ADA Curb Ramp New Construction Inspection Form (Perpendicular)

NW 291 st

23885.56

NW king ave

PERPENDICULAR RAMP (PR)

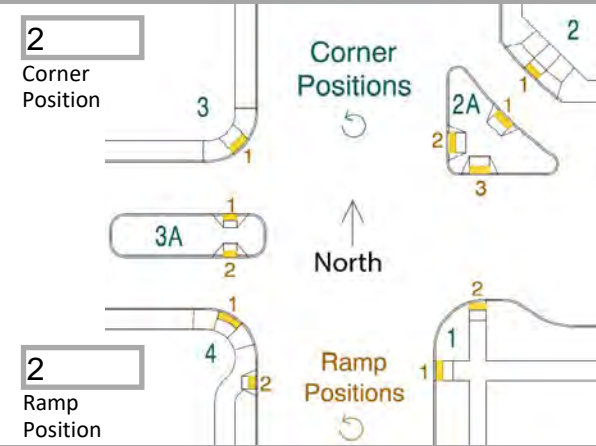
Rr1 icrr tool joints and j box in turn space
